**RE: Exhibition of the Ralston Avenue (Belrose) Planning Proposal at Lot 1 DP 1139826,
TransGrid Objection to Rezoning**

Thank you for your letter dated 29 May 2017 in respect of the abovementioned matter, being the Ralston Avenue (Belrose) Planning Proposal to rezone the subject site to low density residential, public recreation and environmental management zones.

DP1139826

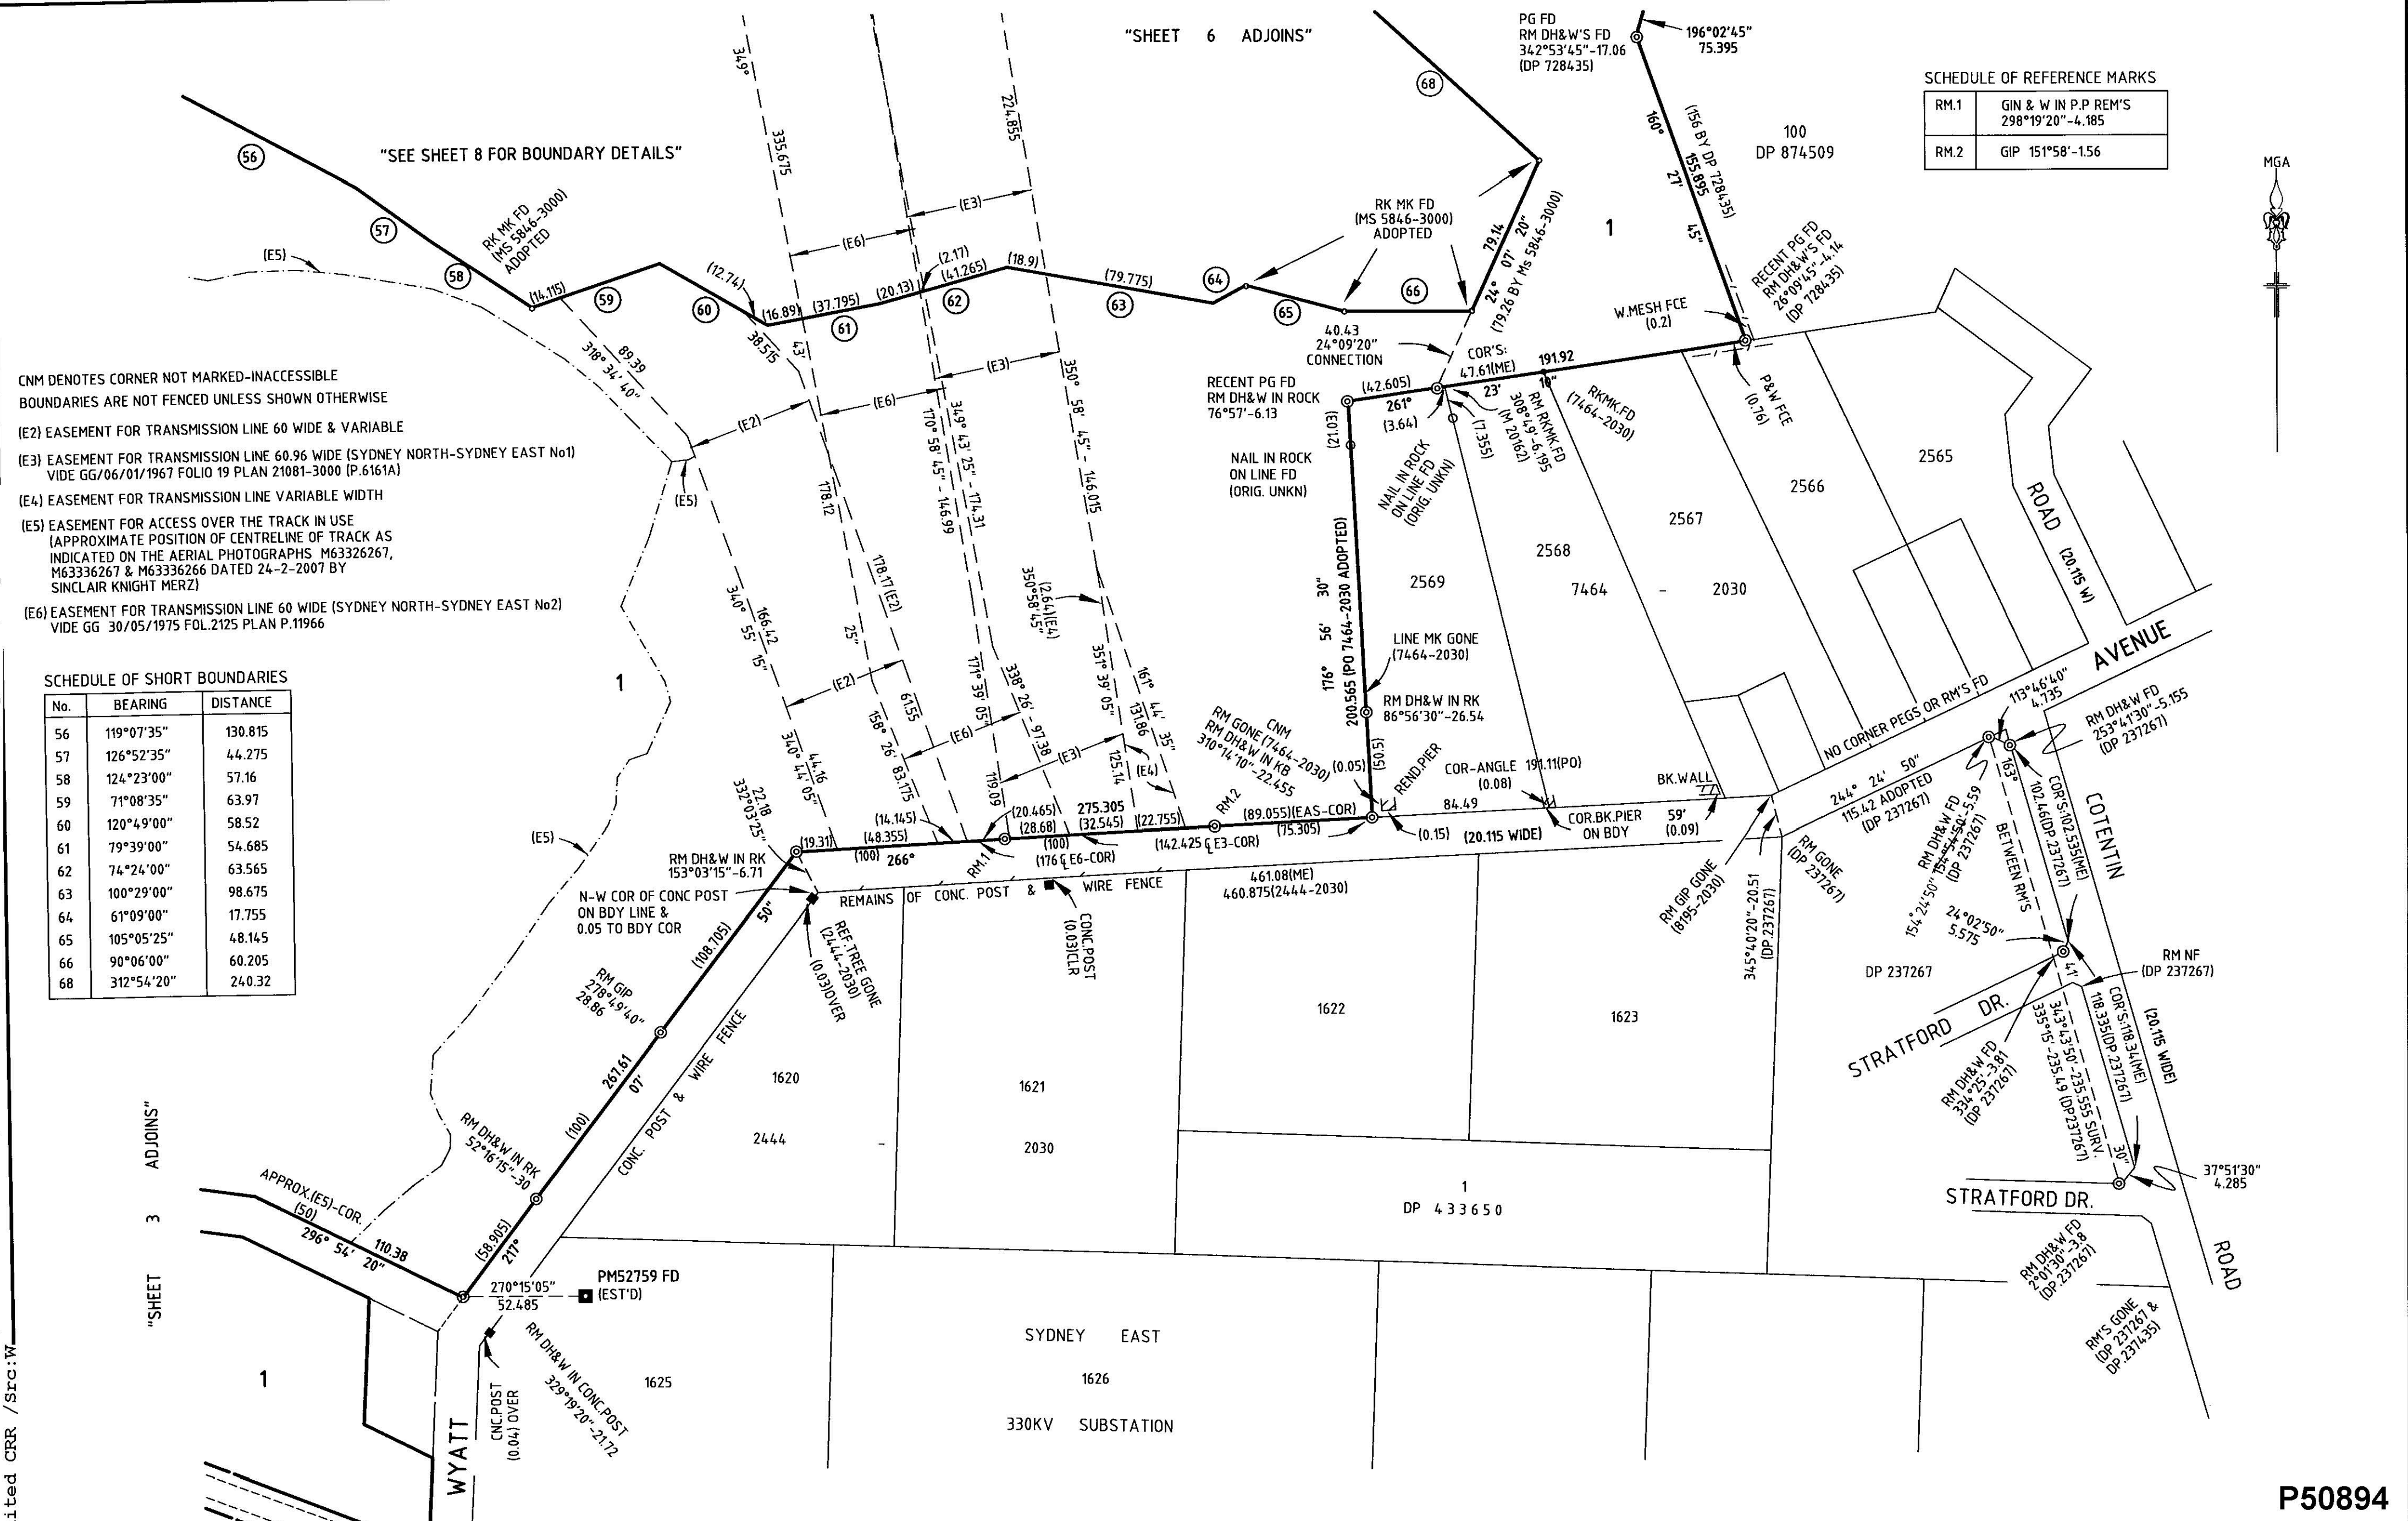
The proposed Wyatt Avenue perimeter road and evacuation route crosses under these transmission lines through TransGrid's easements, which are shown as [E2], [E3], [E4], [E5] and [E6] on DP 1139826. It is currently not known if there is sufficient safe clearance to these lines for any future change in land use. It is possible that an increase in height to the transmission lines may be required to ensure a safe clearance distance to the lines could be achieved. This cost will not be borne by TransGrid and is typically at the cost of the Developer.
